| 8802-3/802.3 REVISION REQUEST |

REQUESTED REVISION:
STANDARD: IEEE Std 802.3ab-1999
CLAUSE NUMBER: 40C.2.1 and Figure 40C-2
CLAUSE TITLE: Auto-Negotiation Transmit state machine add-on
for 1000BASE-T

Figure 40C-2 as modified by Revision requests 1042 to 1049 - Changes annotated

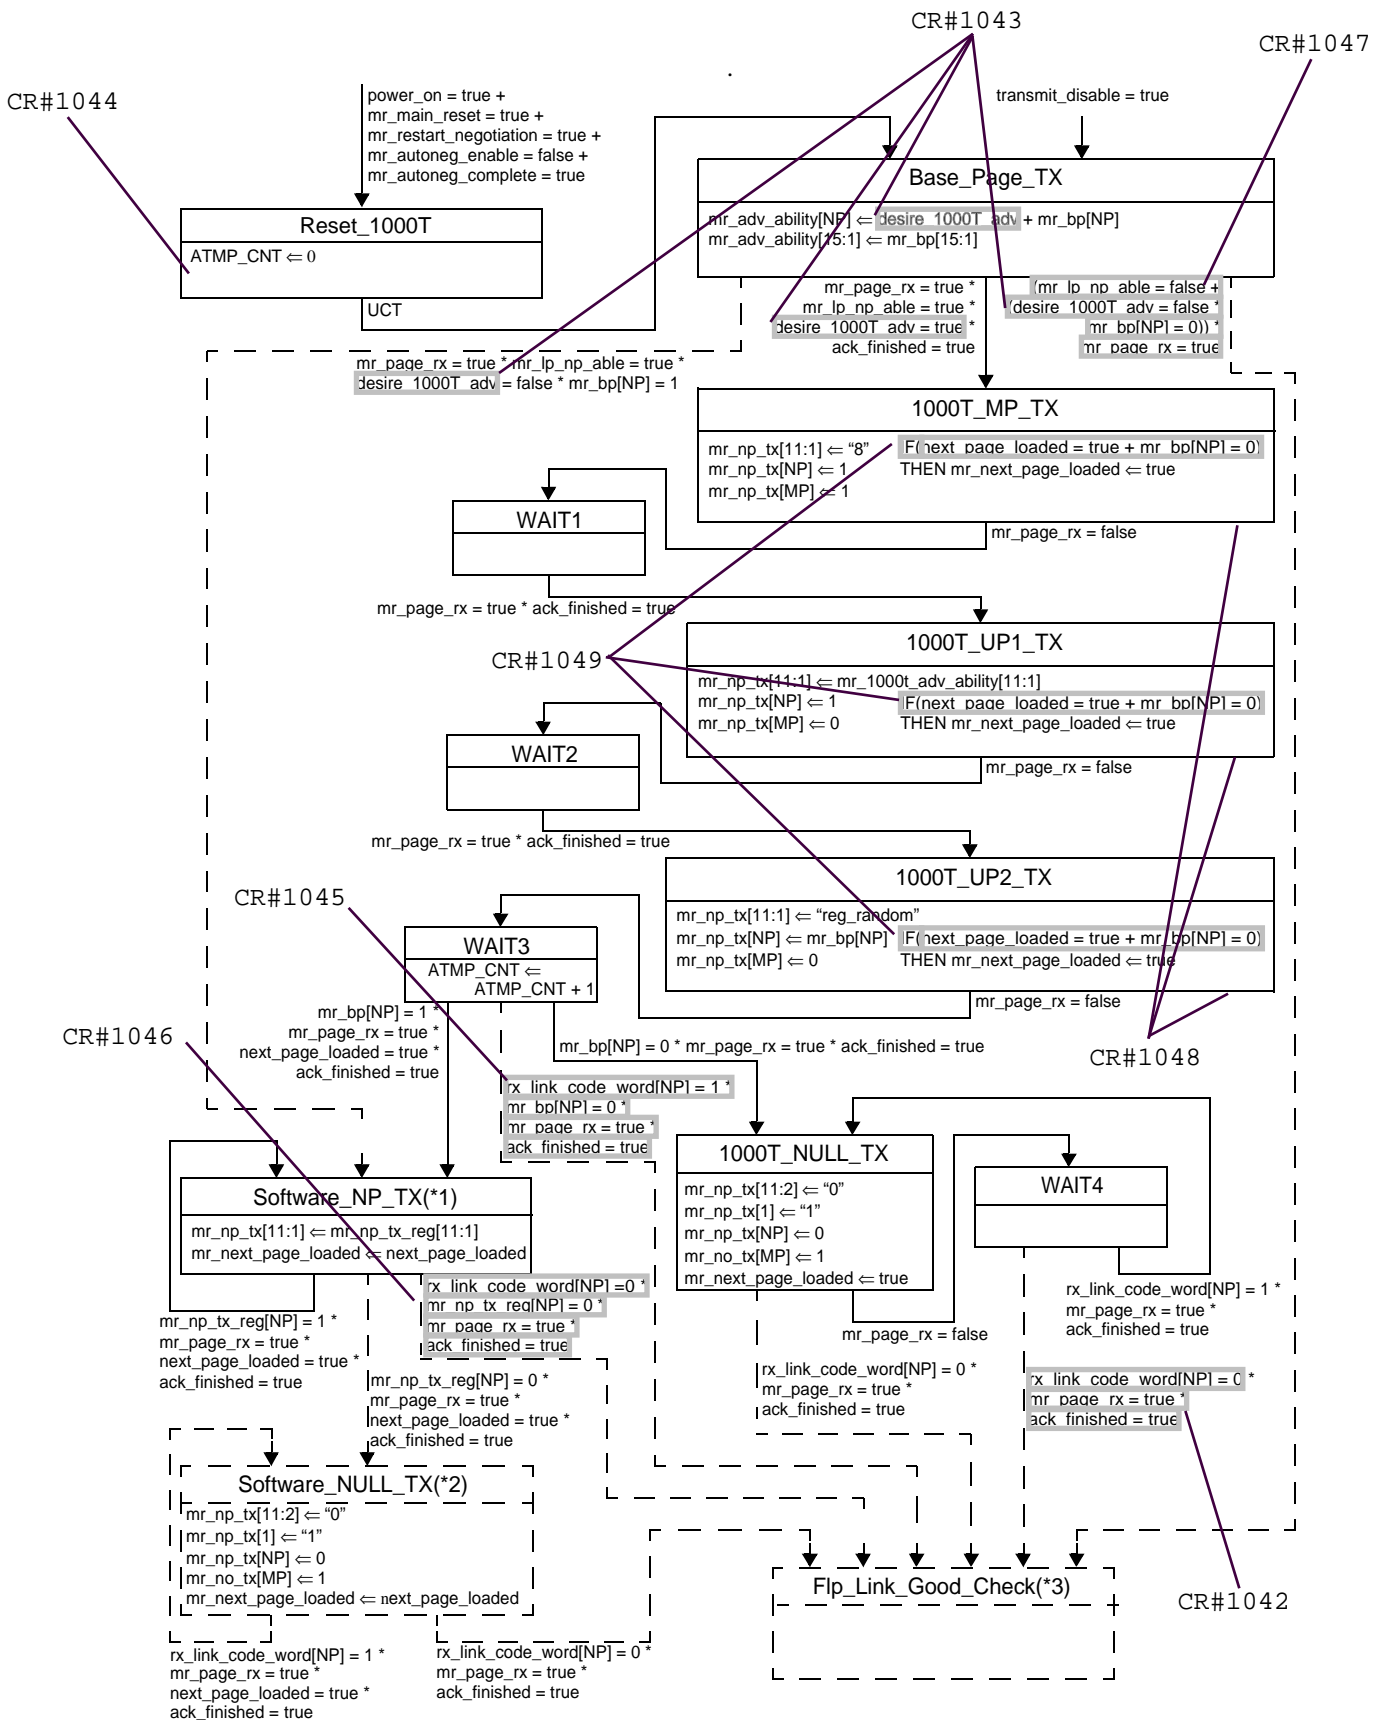
Rename 1000T_capable to desire_1000T_adv.

desire_1000T_adv
The local device desires a 1000Base-T link.
Values: true; bits 9.8 or 9.9 do not contain a logic zero.
false; bits 9.8 and 9.9 both contain a logic zero.

1000T_capable is not descriptive of all devices. A device may be capable of 1000Base-T, but not want to advertise it.
